CITY PLAN COMMISSION**THURSDAY, MARCH 20, 2025****FILE NUMBER:** S245-112**SENIOR PLANNER:** Sharmila Shrestha**LOCATION:** Henderson Avenue, southwest of Madera Street**DATE FILED:** February 19, 2025**ZONING:** PD 462 (Subdistrict 2)**PD LINK:** <https://dallascityhall.com/departments/city-attorney/pages/articles-data.aspx?pd=462>**CITY COUNCIL DISTRICT:** 14**SIZE OF REQUEST:** 0.6651-acres**APPLICANT/OWNER:** Urban Eagle Henderson, LLC

REQUEST: An application to replat a 0.6651-acre tract of land containing all of Lots 6 through 8 and part of Lot 9 in City Block 4/1974 to create one lot on property located on Henderson Avenue, southwest of Madera Street.

PRELIMINARY PLAT
EAGLE NORTH HENDERSON ADDITION
LOT 1, BLOCK 4/1974
 0.6851 ACRES
 J.M. PATTERSON SURVEY,
 CITY OF DALLAS, DALLAS COUNTY, TEXAS
 CITY FILE NO. S245-112
 CITY WASTEWATER NO. _____
 PAVING AND DRAINAGE NO. _____

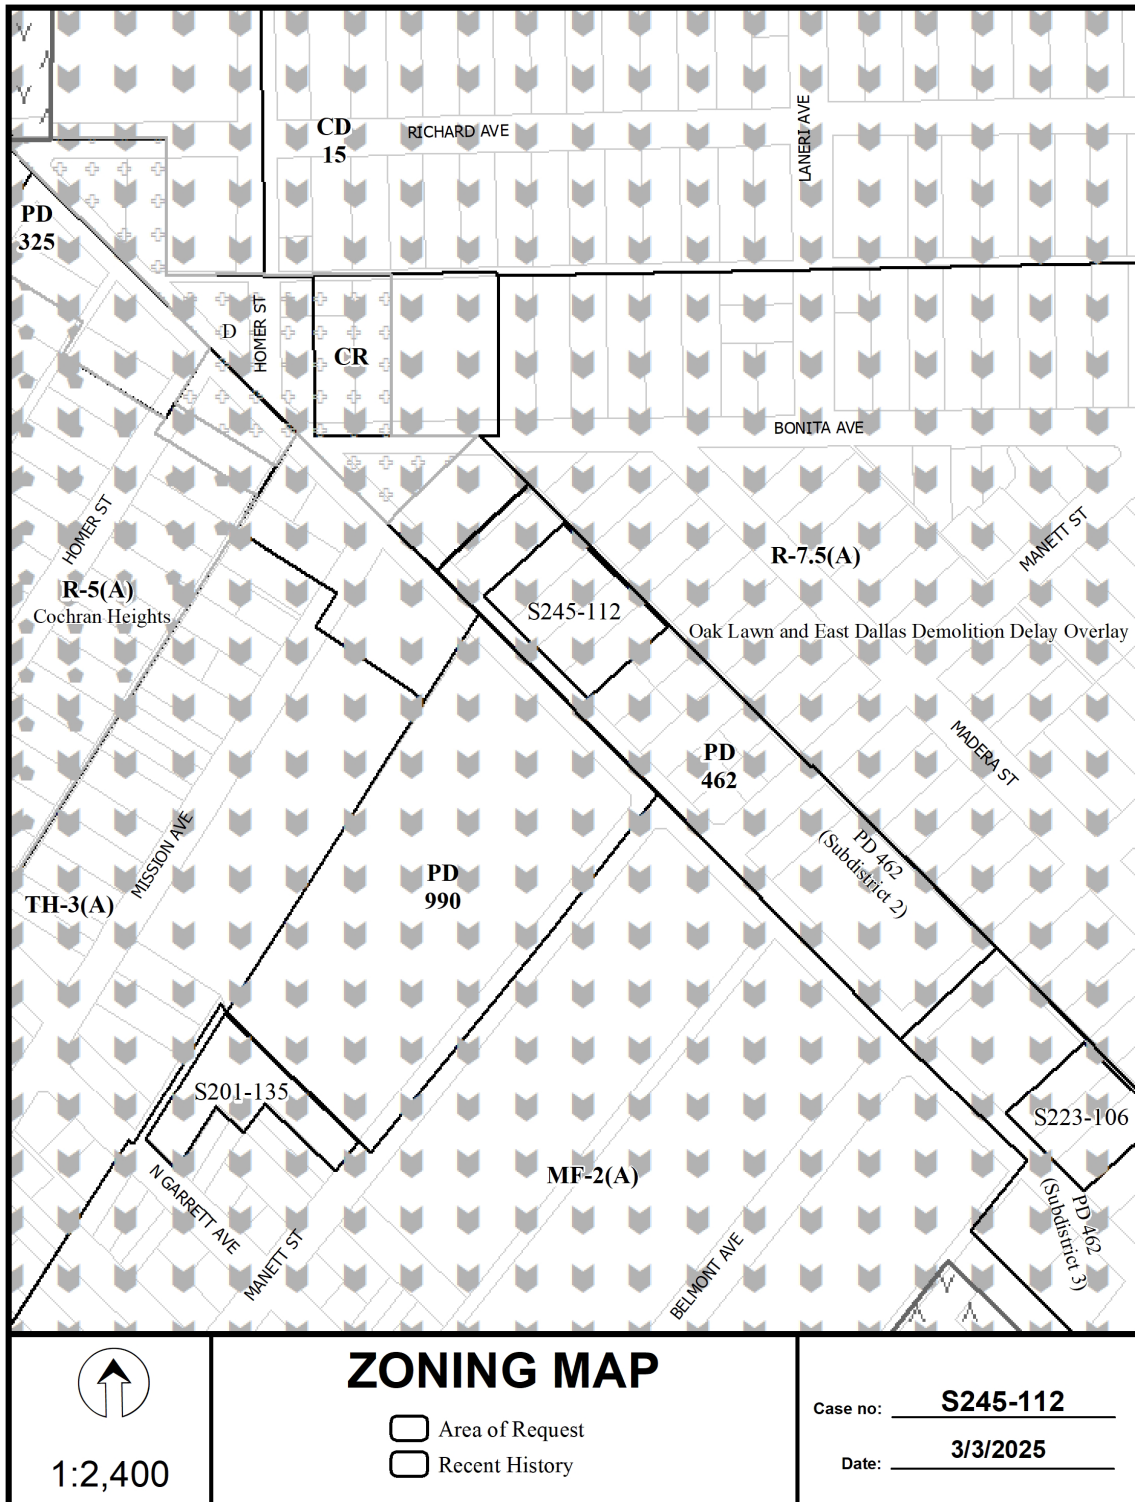
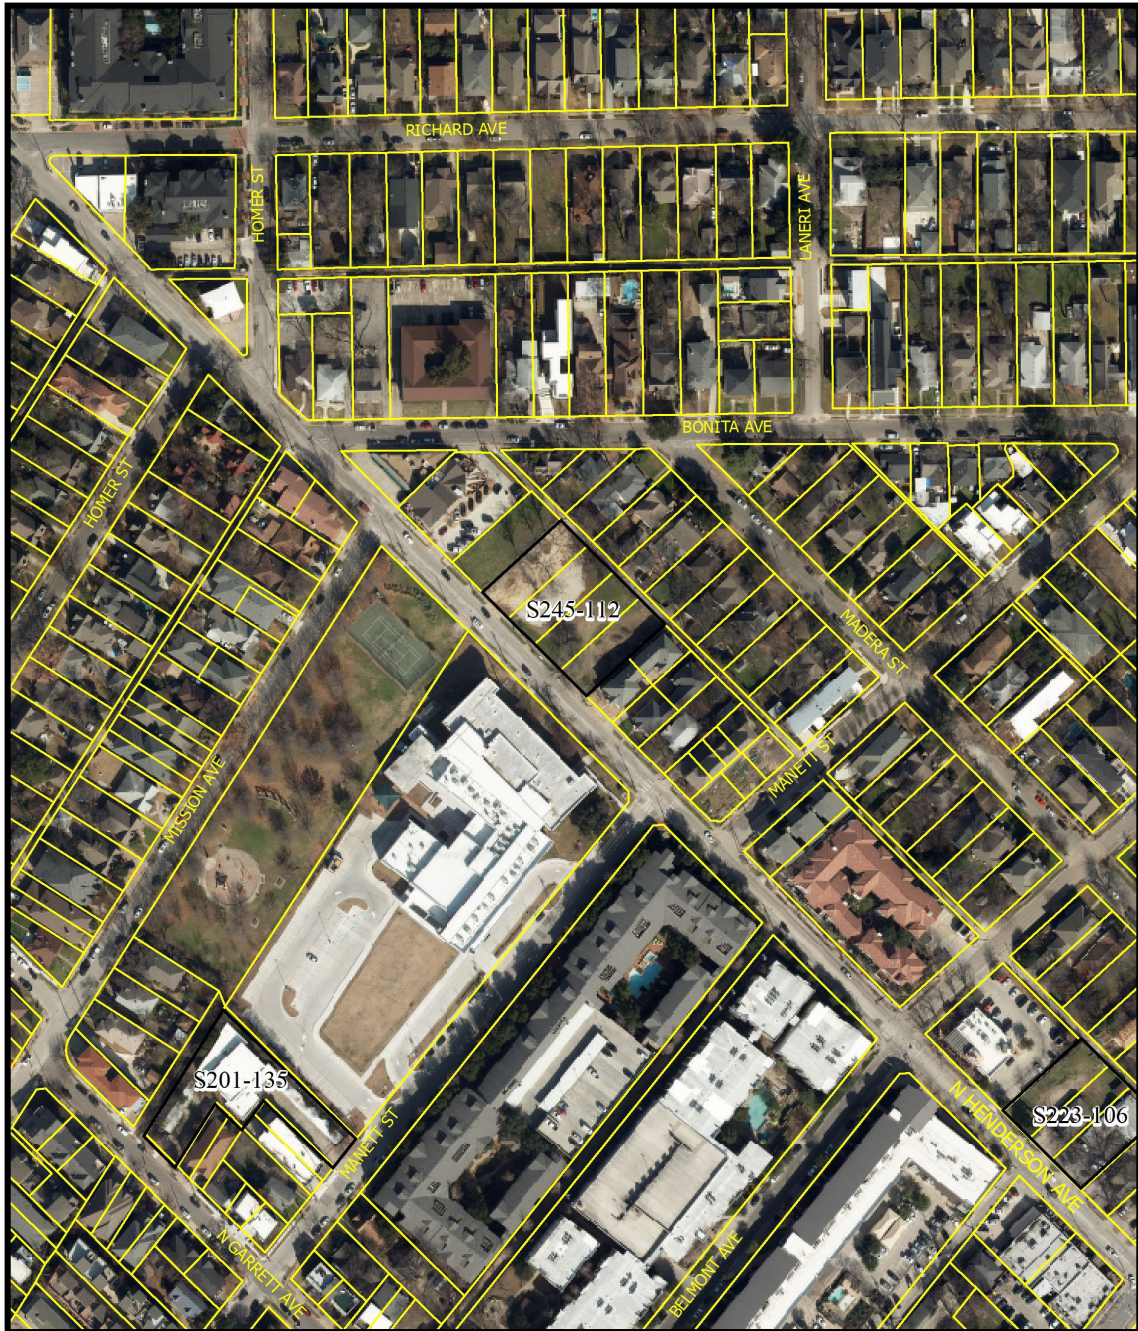
STAFF RECOMMENDATION: The request complies with the requirements of PD 462 (Subdistrict 2); therefore, staff recommends approval of the request subject to compliance with the following conditions:

5. Any new or existing structure may not extend across new property lines. *Section 51A-8.503(e)*
6. On the final plat, all easement abandonments, and ROW abandonments must be by separate instrument with the recording information shown on the face of the plat. A release from the Real Estate Division is required prior to the plat being submitted to the Chairman for signature.

7. On the final plat, include two boundary corners tagged with these coordinates: “Texas State Plane Coordinate System, North Central Zone, North American Datum of 1983 on Grid Coordinate values, No Scale and no Projection.”

8. On the final plat, monument all set corners per the Monumentation Ordinance. Prior to submittal of the final plat for the Chairman’s signature. The monuments must be verified by the Chief City Surveyors Office in the Public Works Department. *Section 51A-8.617*

10. Prior to the final plat, submit a tree survey to the Arborist. A release from the arborist is required prior to an early release request or the recordation of the plat, whichever occurs first.

11. The number of lots permitted by this plat is one.

12. Submit a full set of Civil Engineering Plans (drainage, paving, street signage/markings/lighting) prepared per City Standards by a licensed (TX) Professional Engineer to Engineering Division in Room 200, Oak Cliff Municipal Center (i.e. 311T/DP). Additions and alterations to the public infrastructure require approval and may require private development contracts with bonds. 51A-8.102 (c); 8.601(b)(4),(5),(6),(7),(8),(9)
13. Detention may be required if the capacity of available outfall is not adequate to carry the developed runoff. Section 51A-8.611(c).
14. Place a note on the final plat stating “Lot-to-Lot drainage will not be allowed without proper City of Dallas Engineering Division approval” 51A 8.611(e)

15. On the final plat, dedicate 7.5 feet of right-of-way (via fee simple) from the established center line of Alley. *Section 51A 8.602(c)*
16. On the final plat, dedicate 28 feet of right-of-way (via fee simple or street easement) from the established centerline of Henderson Avenue. *Sections 51A-8.602(c), 51A-8.604(c) and 51A-8.611(c).*

17. Prior to final plat, submit a completed final plat checklist and all supporting documents.
18. On the final plat, show how all adjoining right-of-way was created. Section 51A-8.403(a)(1)(A)(xxii).
19. On the final plat, show recording information on all existing easements within 150 feet of the property.

20. Additional design information is required for assessment. Site plan must be submitted showing proposed development, building finished floor elevation, development, existing mains – including downstream manhole, and proposed water and wastewater service locations. Submit water/wastewater engineering plans to 320 E. Jefferson Blvd., Room 200, Attention: Water and Wastewater Engineering.
21. Water main improvements may be required by Private Development Contract. Submit water/wastewater engineering plans to 320 E. Jefferson Blvd., Room 200, Attention: Water and Wastewater Engineering.

22. Prior to final plat, compliance with City's Street lighting standards including illumination standards, material, installation, and activation per Street Design Manual.
23. On the final plat, identify the property as Lot 6A in City Block 4/1974.
